# SERVICETEKNOTES

Published by Tektronix Service  
Administrative Support

## TABLE OF CONTENTS

Figure 1  
RCU Power Fixture

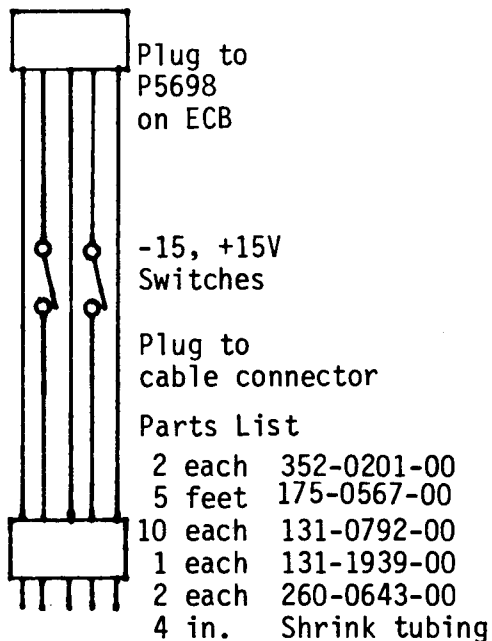
In later model 1440 Mod instruments, the power that is supplied to the RCU passes through diodes CR5691 and CR5692. In older instruments, there were fuses. The calibration procedure starting at step 18 on page 3-7 talks about removing these fuses as a part of the calibration procedure. Since the fuses have now been replaced by soldered in diodes, removal is not a clean and easy process.

In those instruments that use diodes in this application, in order to perform the calibration, the technician has two alternatives:

1. Pull P5698 and temporarily remove the wires from slots 2 and 4 on the 5-pin connector as appropriate for the calibration steps.
2. Construct a fixture as shown in Figure 1. This fixture can then be inserted in series with the connection at P5698, and will provide the ability to disable the RCU supplies.

1800 SERIES EXTERNAL SYNC TEST  
FIXTURE MODIFICATION, M49789

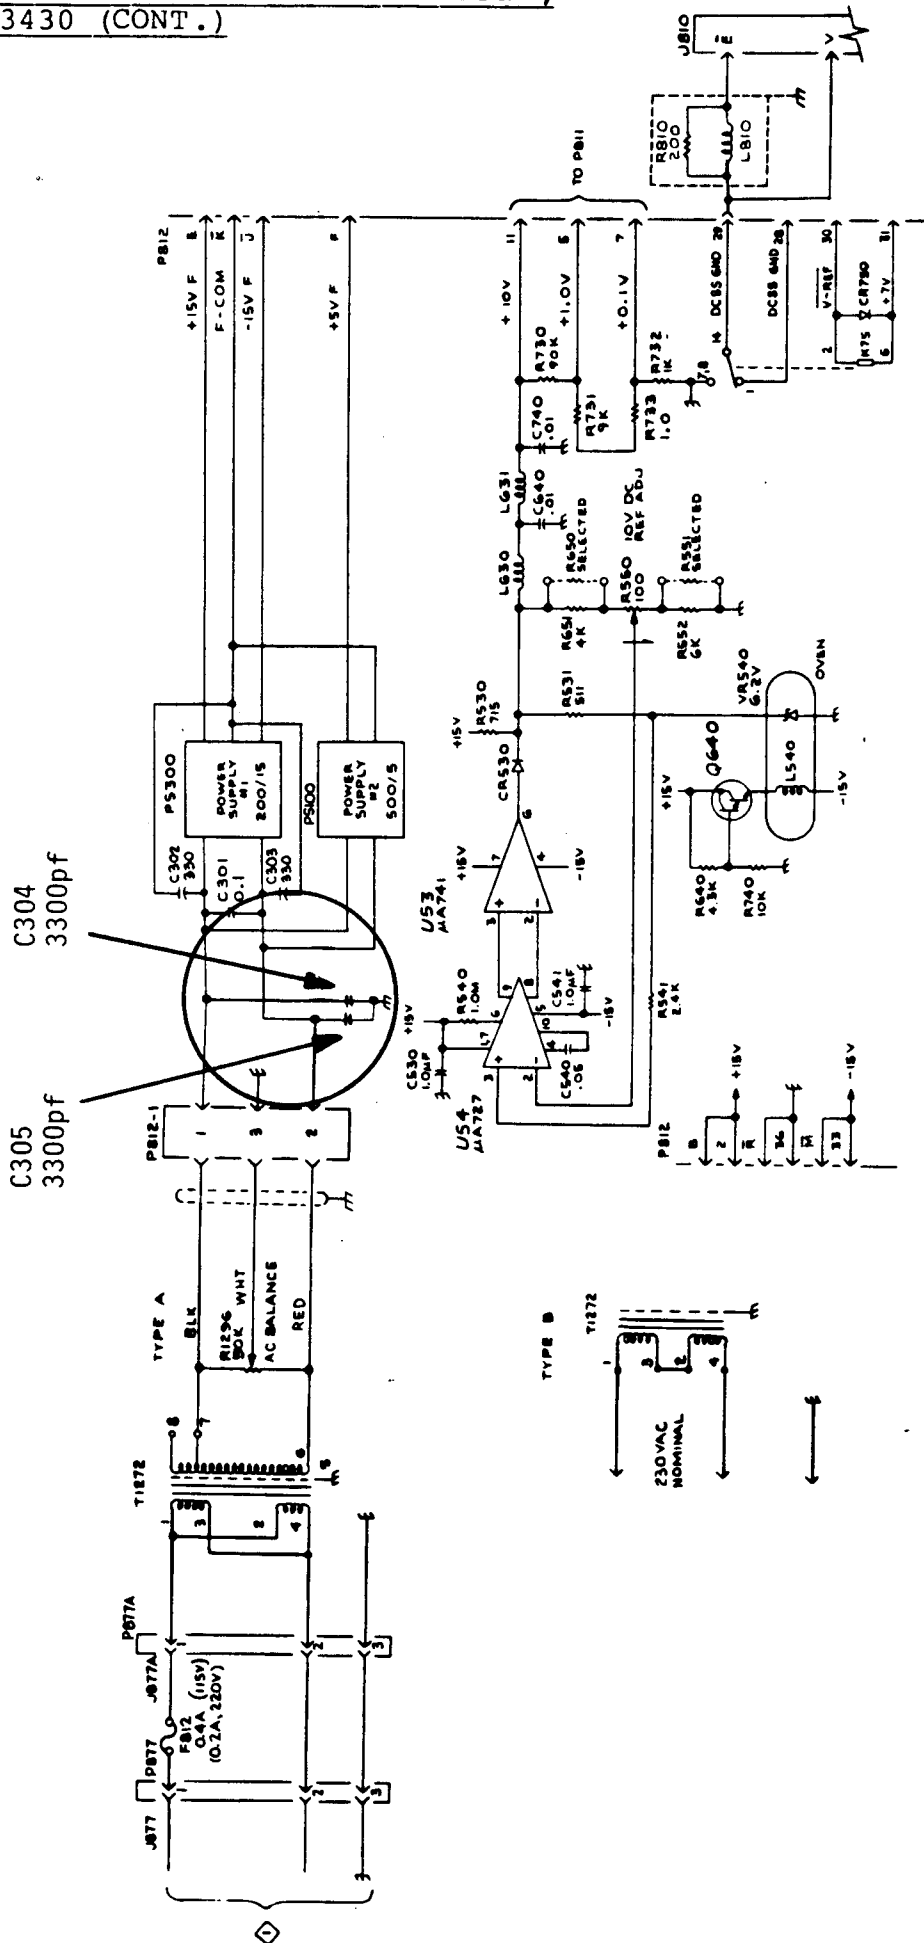
Integrated circuit, U100, P/N 156-0861-01 is being replaced on the External Sync Test Fixture P/N 067-0953-00.

The Texas Instruments IC, a 74LS124 VCO was recently discontinued by the vendor and replaced with a part which was to be "at least as good." The new IC, a 74LS629 VCO was actually "too good" and oscillated at several hundred percent higher frequency.

This modification establishes a parts replacement kit P/N 050-1751-00. Included in the kit are the new IC and two frequency-of-oscillation determining capacitors, C101 and C111.

The External Sync Test Fixture is now P/N 067-0953-01. The subassembly 670-6485-00 should be changed to 670-6485-01.

PS 812 DC SUBSYSTEM  
FLOATING POWER SUPPLY CARD  
New:  
670-2554-05

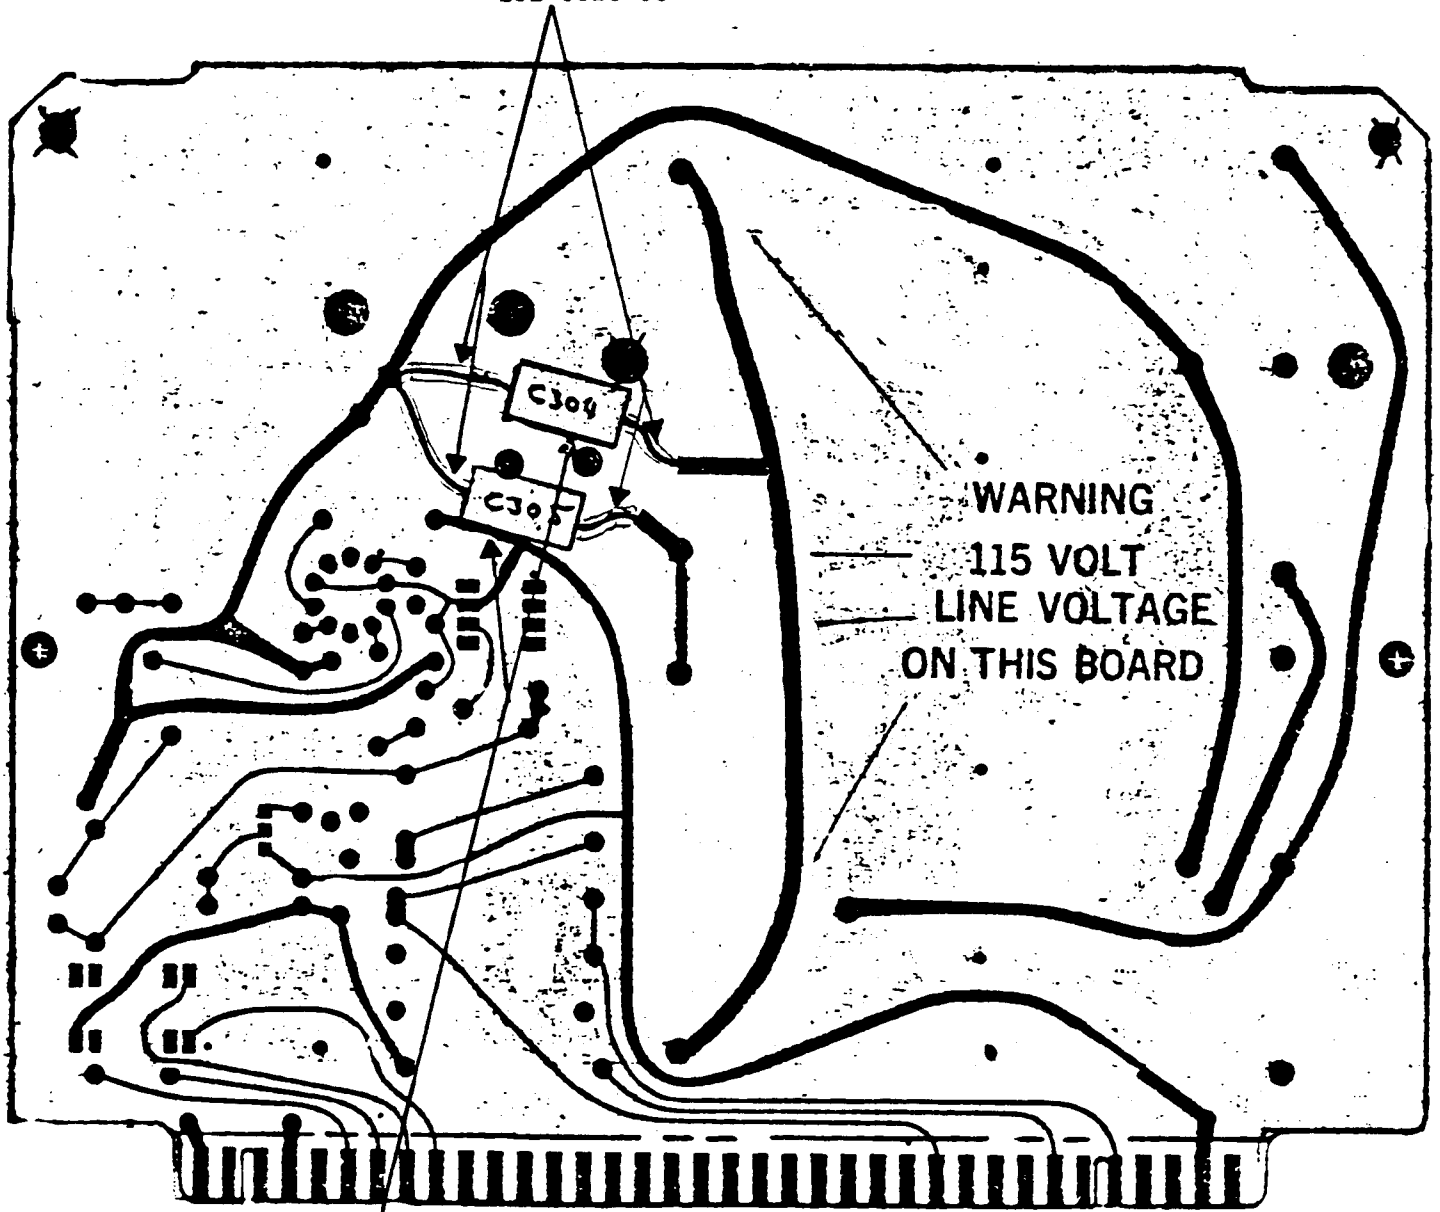
1800 DCSS FLOATING POWER SUPPLY,  
#M43430

Switching noise on the AC line gets on the floating common of the DC subsystem and may cause F040 (T1140A.EDT) to fail.

Addition of C304 and C305 (283-0041-00) will bypass noise to ground. C304 and C305 should be installed on the back side of the Floating Power Supply Circuit Board, 670-2554-04. Installation of this change also includes changing the circuit board part number to 670-2554-05.

Insulation sleeving (162-0026-00) should be added to the capacitor leads to prevent shorting.

MOD M43430 adds two  
.0033uf capacitors  
(C304 and C305) as  
shown above.

C304 & C305  
283-0041-00  
.0033uF, 5%, 500V

AFTER MOD 43430

Date: 4-18-83 Change Reference: M50871

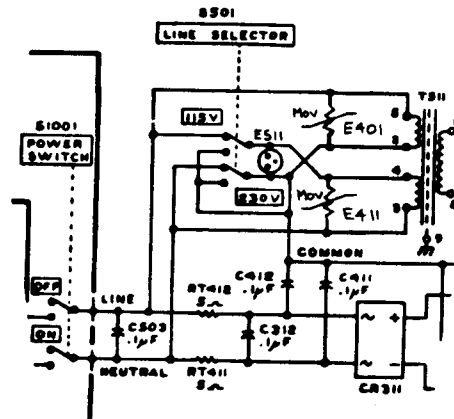
Several inputs from the field have indicated that the 1980 power supply had an occasional tendency to blow the line fuse upon turn-on, or during a line transient. This has been a particular problem in the 620-0286-01 supply when used in a 240 volt 50 cycle environment.

A recent mod (#50871) has been implemented to solve this problem. The result of the mod is that some fuse value changes and transient protecting devices are now being installed in the power supply module (620-0286-01) in the manufacturing area. In addition, a field mod kit has been set up to allow field service technicians and self service customers to implement the correction. The field mod kit is P/N 050-1783-00, and upon installation, the 620-0286-01 becomes a 620-0286-02.

EFF SN B030268 ELECTRICAL PARTS LIST AND SCHEMATIC CHANGES

A60	620-0286-02	CKT BOARD ASSY:POWER SUPPLY (OPTION 02 & OPTION 05 ONLY)
A60A1	670-6046-02	CKT BOARD ASSY:INVERTER (USED WITH 620-0286-02 ONLY)
A60A1E401	307-0449-00	RES., VAR, SENSITIVE:1900PF, 100A, 340V
A60A1E411	307-0449-00	RES., VAR, SENSITIVE:1900PF, 100A, 340V
A60A1E511*	119-0181-00	ARSR, ELEC SURGE:230, GAS FILLED
A60A4	670-7444-01	CKT BOARD ASSY:LINE FILTER (USED WITH 620-0286-02 ONLY)
A60A4F1	159-0211-00	FUSE, CARTRIDGE:3AG, 5A, 250V SLOW BLOW (FOR 115V OPERATION)
A60A4F1	159-0217-00	FUSE, CARTRIDGE:3AG, 2.5A, 250V SLOW BLOW (FOR 230V OPERATION)

The above added part, E511, is located on the A60A1 INVERTER BOARD and shown on diagram 11a - Partial

Figure 1.

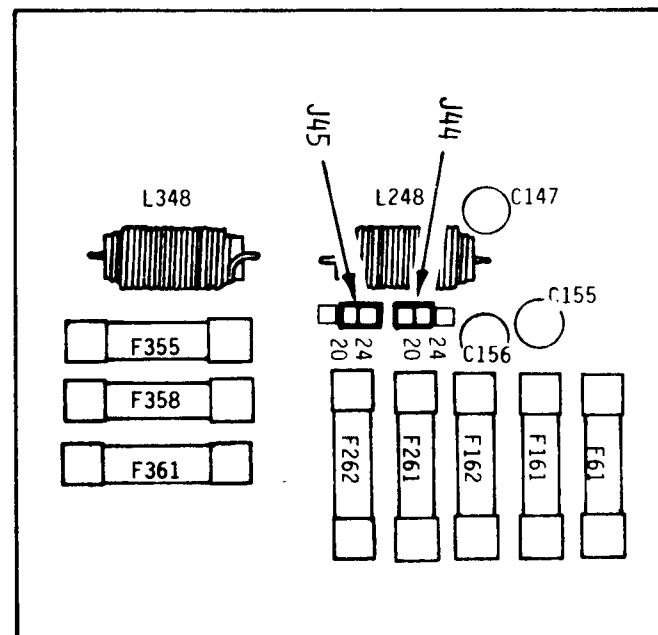
One possible cause of premature failure of replacement CRTs in 4016 terminals and GMA125 monitors are flood gun heater straps that are not set for optimal performance. When a CRT is replaced, the flood gun heater straps, J44 and J34 on the secondary LVPS board, should be placed in the 44V settings. Leaving the straps in the 48V settings may severely curtail the life of the CRT. The 48V setting is used to extend the life of an old CRT. The 40V setting is not recommended because it may cause early CRT failures. To strap J44 and J45 to the 44V setting, it requires that one be strapped to 20V and the other to 24V. They are strapped to 48V when both J44 and J45 are in the 24V position.

Schematic Changes

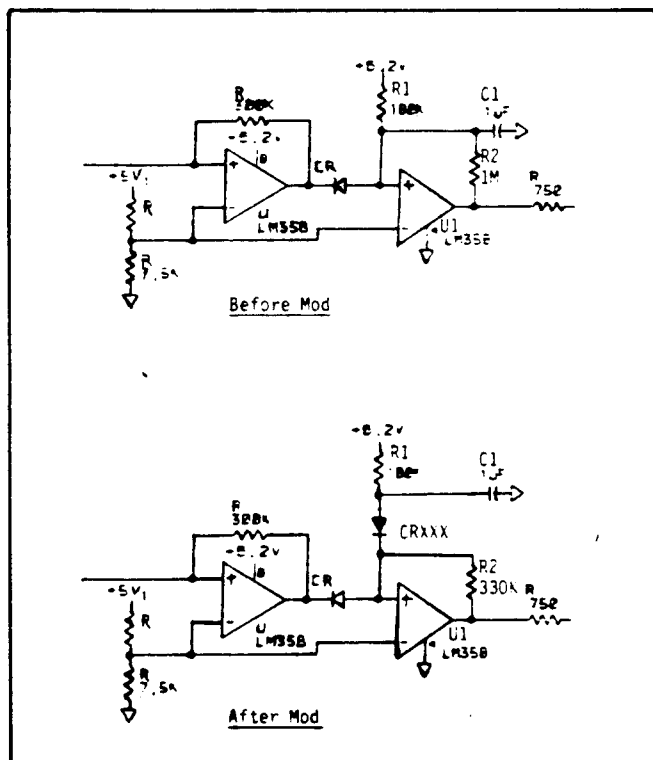
Identical power up restart circuits on the 4052/4052A power supply, 4054/4054A I/O boards and the 4050E01 power supply have a design defect which can cause the restart signal to pulse several

times. This can cause the system to hang or for the 4050E01 to power up in the opposite mode than the product to which it is connected. The malfunction can also show up on the 4050E01 as intermittently changing modes.

One end of both a 1 uf cap (C1) and a 180K  $\Omega$  resistor (R1) are connected to the plus input of the OP AMP (U1) in the circuit involved. Lift this end of both components and "teepee" together. Insert and solder in the cathode end of a 1N4152 diode (CRXXX) into the hole from which the end of the "teepeed" resistor (R1) was removed. Connect the other end of the diode to the "teepeed" resistor and capacitor (R1, C1) and solder together. Last, replace the 1M  $\Omega$  resistor (R2) with a 330K  $\Omega$  resistor. Below are part numbers for CRXXX and R2.

Board Name - Input/Output Board  
Board P.N. - 670-7630-01 rolls to -02  
Ckt. Involved - U265B (+ input = pin 5)  
Lift - R265 and C267  
Add - CR265  
Change - R266

Board Name - Power Supply Ckt. Bd.  
Board P.N. - 670-7210-01 rolls to -02  
Ckt. Involved - U205A (+ input = pin 3)  
Lift - R202 and C202  
Add - CR203  
Change - R201

Board Name - Regulator Circuit Board  
Assy. P.N. - 620-0278-00 rolls to -02  
Bd Assy P.N. - 672-0833-01 rolls to -03  
Ckt. Involved - U271A (+ input = pin 3)  
Lift - R272 and C271  
Add - CR272  
Change - R263

Board Name - Input/Output Board  
Board P.N. - 670-5666-02 rolls to -03  
Ckt. Involved - U270B (+ input = pin 5)  
Lift - R260 and C262  
Add - CR261  
Change - R261
